PJM Manual 14D:

Generator Operational Requirements

Revision: 6866

Effective Date: July 23, 2025 ~~December 18, 2024~~

Exhibit 7: Metering requirements example for a Mixed Technology Facility

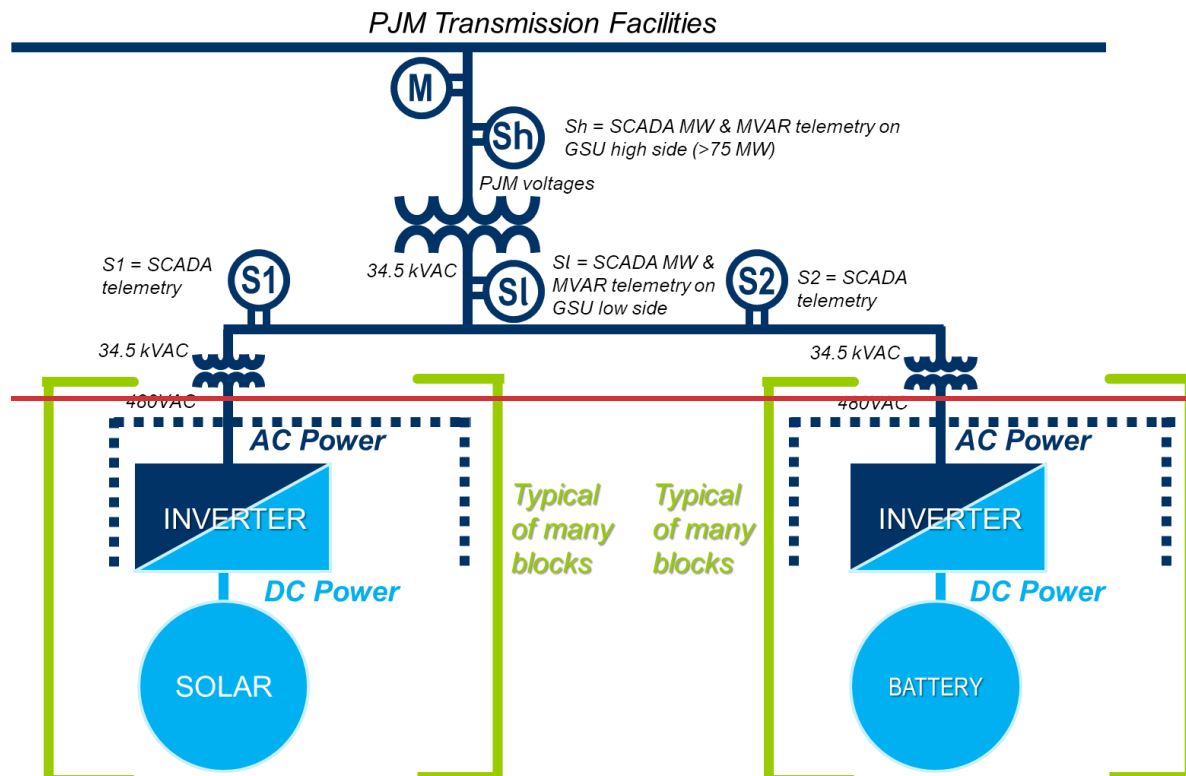
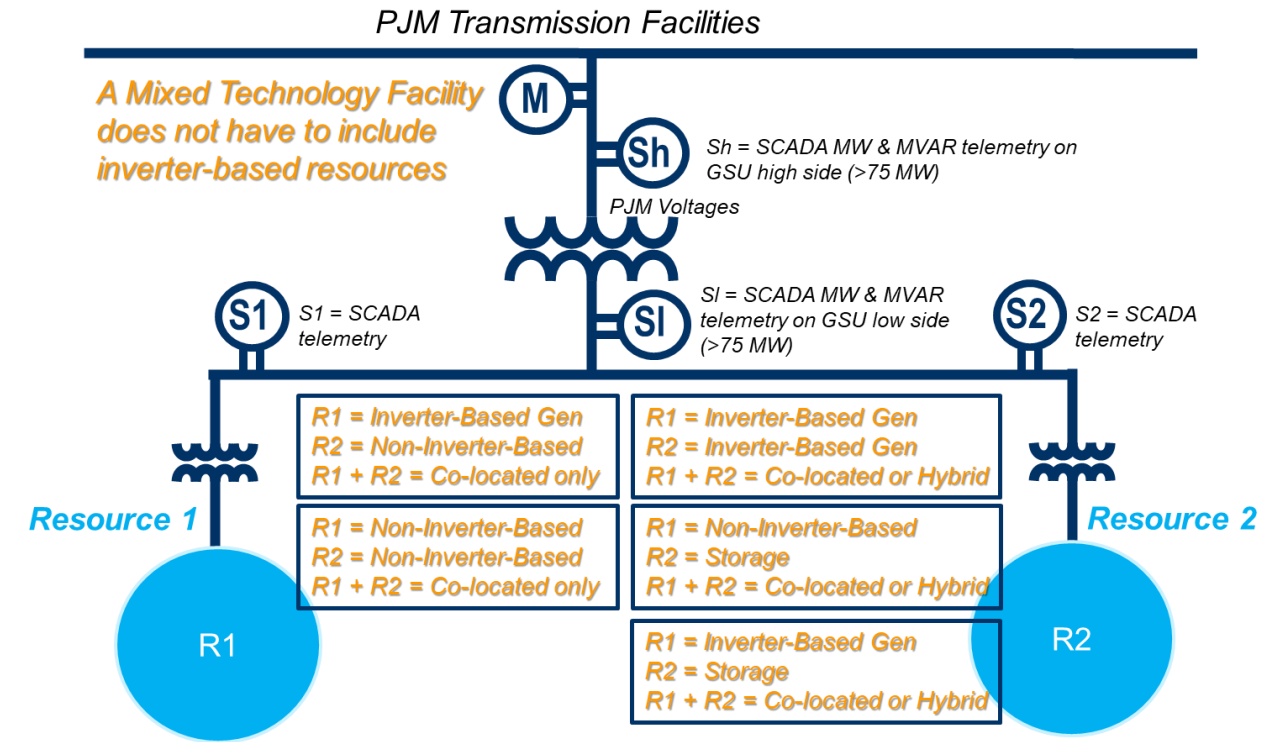
Exhibit 7 below illustrates an example of a Mixed Technology Facility with combinations of inverter-based (including storage) or non-inverter-based resources ~~a solar resource and an Energy Storage Resource~~, each participating separately in markets as a Co-Located Resource. In this example, all of the energy measured for the Mixed Technology Facility at “M” across an interval (e.g., 5 minutes) is split between the combination of resources ~~solar resource and the Energy Storage Resource~~ pro rata according to the power measured at S1 (which measures all of the R1 power flows ~~solar production~~) and at S2 (which measures all of the R2 power flows ~~storage power flows~~) integrated over the interval.

Mixed Technology Facilities

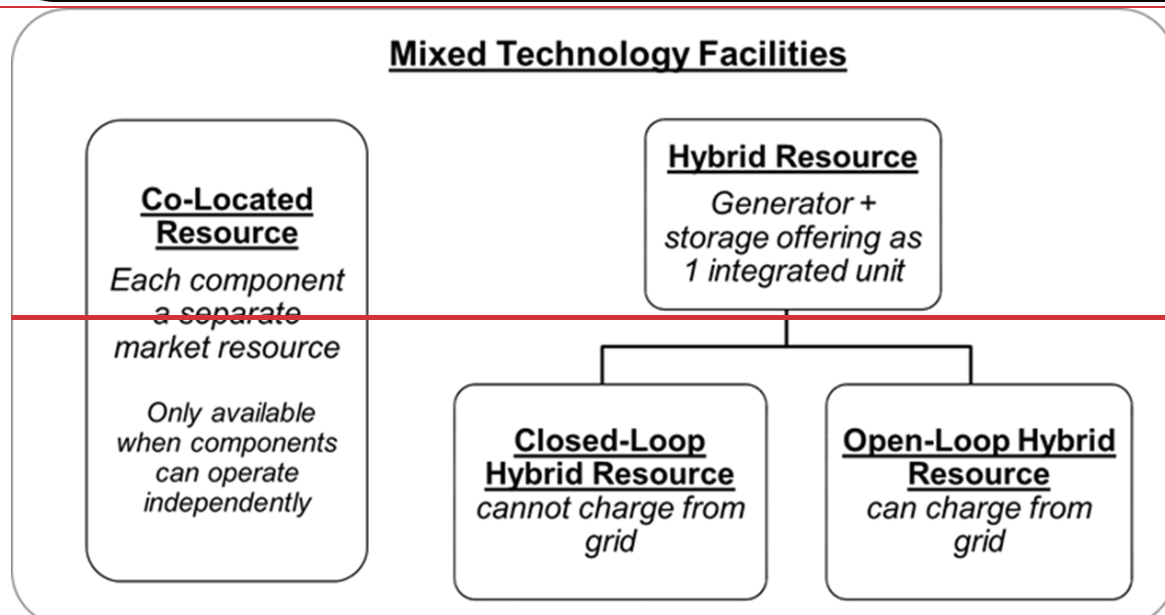
A Mixed Technology Facility ~~consisting of one electric storage component and one generation component features significant interaction when it meets any of the following criteria. Such a facility must participate in markets as a Hybrid Resource if .~~ The criteria are:
~~The Mixed Technology Facility includes a storage component that is physically incapable of charging from the grid, is physically or contractually incapable of withdrawing power from the grid to charge the electric storage component (i.e., it is a closed-loop facility).~~
 The nameplate real power ratings of the components of the Mixed Technology Facility sum to greater than 100% of the Maximum Facility Output recorded in the Generation Interconnection Agreement, Interconnection Service Agreement, or Wholesale Market Participation Agreement.

~~of the Mixed Technology Facility.~~
